Response to the Reviewers' Comments

The authors would like to thank the reviewers for the precious comments and suggestions on the technical contents and presentation of our manuscript “Runtime Power Management of Battery Electric Vehicles for Extended Range with Consideration of Driving Time,” submitted to IEEE Transactions on Very Large Scale Integration (TVLSI.) This revised manuscript has been greatly improved thanks to the reviewers’ invaluable advices. We have revised the manuscript faithfully following the reviewers’s comments. We include the newly added or significantly modified parts in the revised version of the paper also in Response to Reviewers. We highlight the important technical content changes and set those parts in a red color in the revised paper.

Fig. 2: (a) Range-speed experimental data for Chevrolet Bolt [36] and (b) comparison with simulation results of the proposed EV power model.

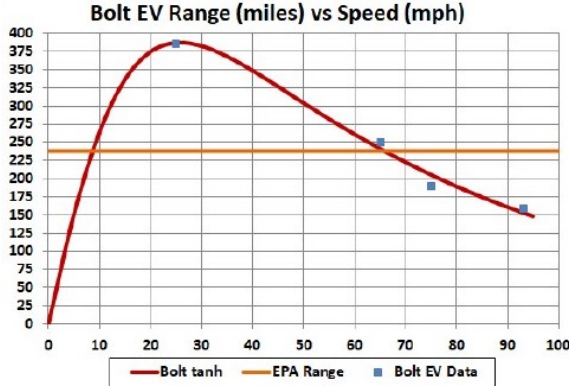
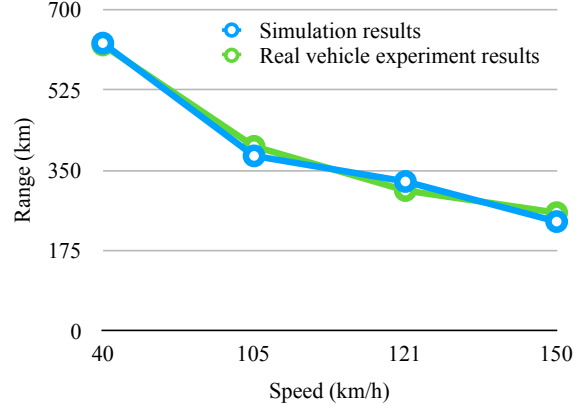
R1-C2 It is not clear how to validate the power model of EV. As the author mentions that accuracy of power model is quite important, it is good to see the power model in this paper can be validated by some real measurement results.

We further evaluate the model accuracy with the range-speed real vehicle experiments as shown in Fig. 2(a) to confirm the derived power models are close enough to the real vehicle measurement data [32], [33], [34], [35], [36]. We refine the coefficients until all the available data values match well.

As a result, the derived EV power model well matches with the range-speed experimental data as shown in Fig. 2(b) as well as the top speed and maximum acceleration setting the aerodynamic resistance, rolling resistance, curb weight, etc. with the known values. The errors in the range-speed simulation is merely 1.4%, the time for 0-to-100 km/h error is 7.8%, and the top speed error is 3.0%, respectively. We revised the manuscript adding the following paragraph with a new figure in Section III.A on page 3 and 4.

We further evaluate the model accuracy with the range-speed real vehicle experiments as shown in Fig. 2(a) to confirm the derived power models are close enough to the real vehicle measurement data [32], [33], [34], [35], [36]. We refine the coefficients until all the available data values match well.

As a result, the derived EV power model well matches with the range-speed experimental data as shown in Fig. 2(b) as well as the top speed and maximum acceleration setting the aerodynamic resistance, rolling resistance, curb weight, etc. with the known values. The errors in the range-speed simulation is merely 1.4%, the time for 0-to-100 km/h error is 7.8%, and the top speed error is 3.0%, respectively.

Fig. 12: Velocity profile comparison with EDP , E^2DP and E^3DP on Serrano Avenue in Anaheim Hills.

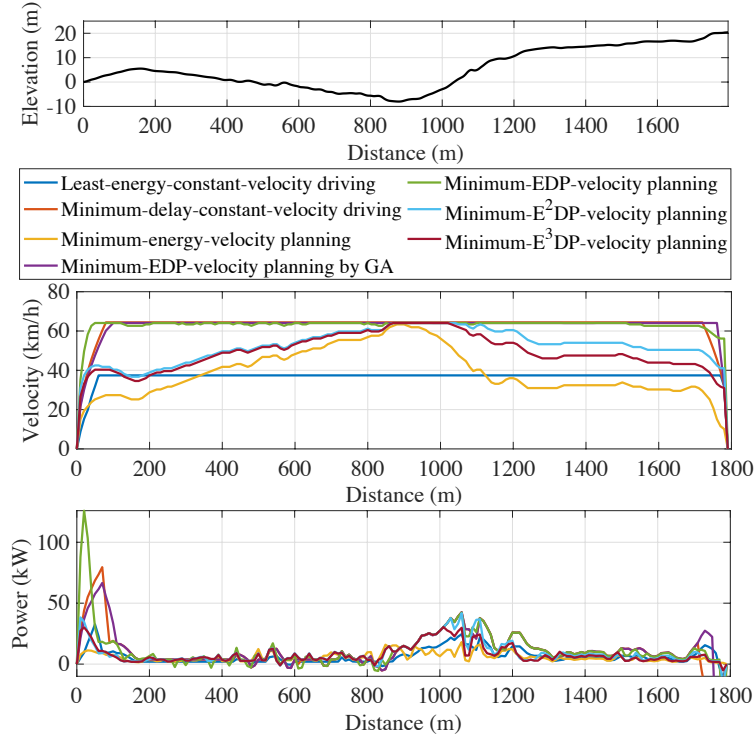
R1-C3 The optimality of the proposed scheduling algorithm is unclear. The author should add several paragraphs to discuss this topic. It is also to see the comparison baseline is well accepted to show the advantage of the proposed algorithm.

We also updated Fig. 12 and Fig. 13:

Fig. 11: Histograms of velocity and acceleration for the proposed energy-aware-velocity planning methods without an acceleration constraint (a) and (b) and with an acceleration constraint (c) and (d), respectively.

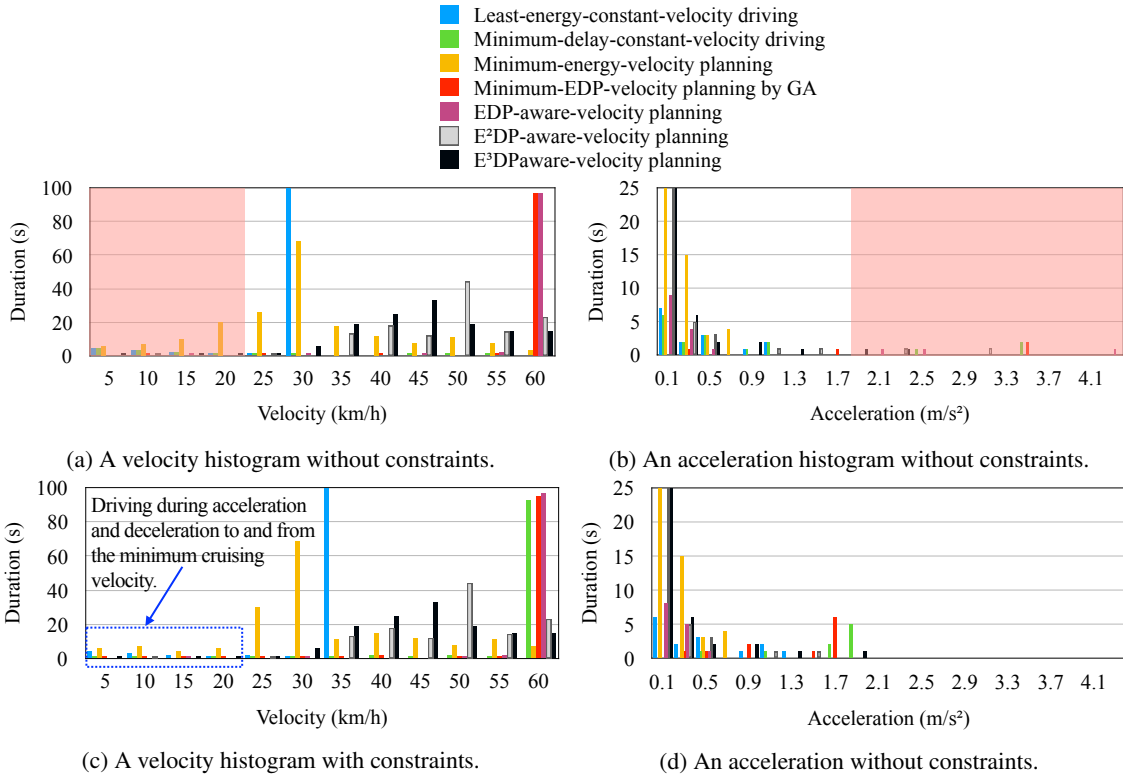
R2-C2 It would be good to have more discussion on the assumptions of the approach and the experiments, e.g., how much can the velocity be changed in practical scenarios without impeding traffic and causing unsafe situations (also depending on the road conditions and whether it is urban or rural environment I suppose). Currently, there only seems to be one constraint on not slower than 10 km/h.

We quantize the velocity and acceleration values and make a histogram to analyze population of velocity and acceleration for the proposed energy-aware-velocity planning methods. Fig. 11(a) and (b) show two histograms of the driving schemes in Fig. 12, which do not have velocity and acceleration constraints. We avoid a cruising

velocity lower than 25 km/h and an acceleration higher than 2.0 m/s^2 in this paper without loss of generality. The acceleration of 2.0 m/s^2 is the same as the maximum acceleration of compact cars designed to be used primarily used in urban areas (13 seconds of 0-to-100 km/h time).

Fig. 11(c) and (d) shows the velocity and acceleration histograms with the constraints. Once we run the DP for the first time without constraints, we analyze the histogram, adaptively determine the minimum cruising velocity and maximum acceleration constraints, and run DP again. We keep the same constraints for online recomputation whenever unexpected interrupts occurs.

We also enforce the minimum acceleration not lower than 1.0 m/s^2 when the EV starts from a stop sign or a traffic light until the velocity reaches to the minimum cruising velocity not to bother traffic flow. The acceleration of a 1.0 m/s^2 exhibits 6 second delay to reach 25 km/h. The maximum speed is bounded by the speed limit of each road benchmark.

Fig. 8: Altitude changes in the real road benchmarks.

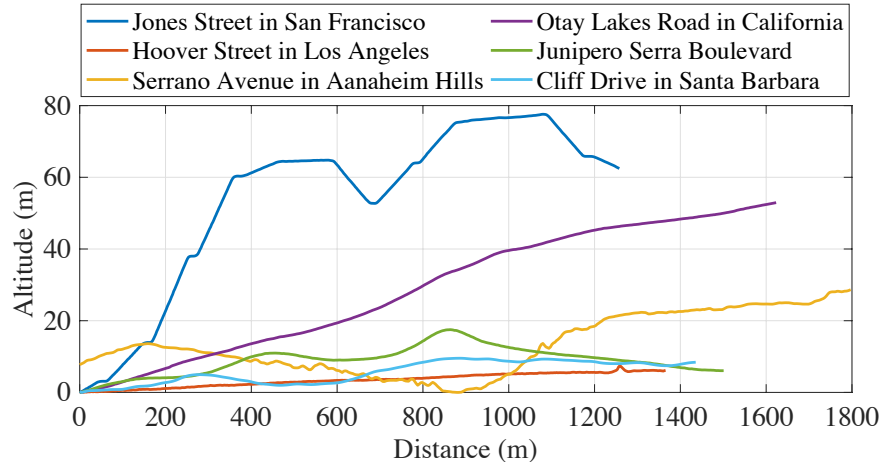
R2-C3 Related to the last point, it would be good to have more discussion on the road benchmarks, e.g., how they are generated and how representative they are. The optimization results significantly depend on road slope. It would be good to use a variety of real road segments for testing.

R2-A3 We appreciate the reviewer's comment. We replaced the previous synthetic road benchmarks with the real road benchmarks. We made six new real road benchmarks from various locations in California. The first three roads are in cities. Jones Street in San Francisco and Hoover Street in Los Angeles are two representative city landscapes such as hills and flat roads, respectively, and Cliff Drive in Santa Barbara is a mixture of those. The second two roads are in mountain areas: Serrano Avenue in Anaheim Hills and Otay Lakes Road in San Ysidro Mountain in California. The last road is Junipero Serra Boulevard connecting San Francisco and San Jose. The details of road data is summarized in Table II, and Fig. 8, which visualize the altitudes of the road benchmarks. We also revised all the associated contents with the new real road benchmarks.

We choose six roads from various locations in California and make real road benchmarks. The first three roads are in cities. Jones Street in San Francisco and Hoover Street in Los Angeles are two representative city landscapes such as hills and flat roads, respectively, and Cliff Drive in Santa Barbara is a mixture of those. The second two roads are in mountain areas: Serrano Avenue in Anaheim Hills and Otay Lakes Road in San Ysidro Mountain in California. The last road is Junipero Serra Boulevard connecting San Francisco and San Jose. The details of road data is summarized in Table II, and Fig. 8, which visualize the altitudes of the road benchmarks.
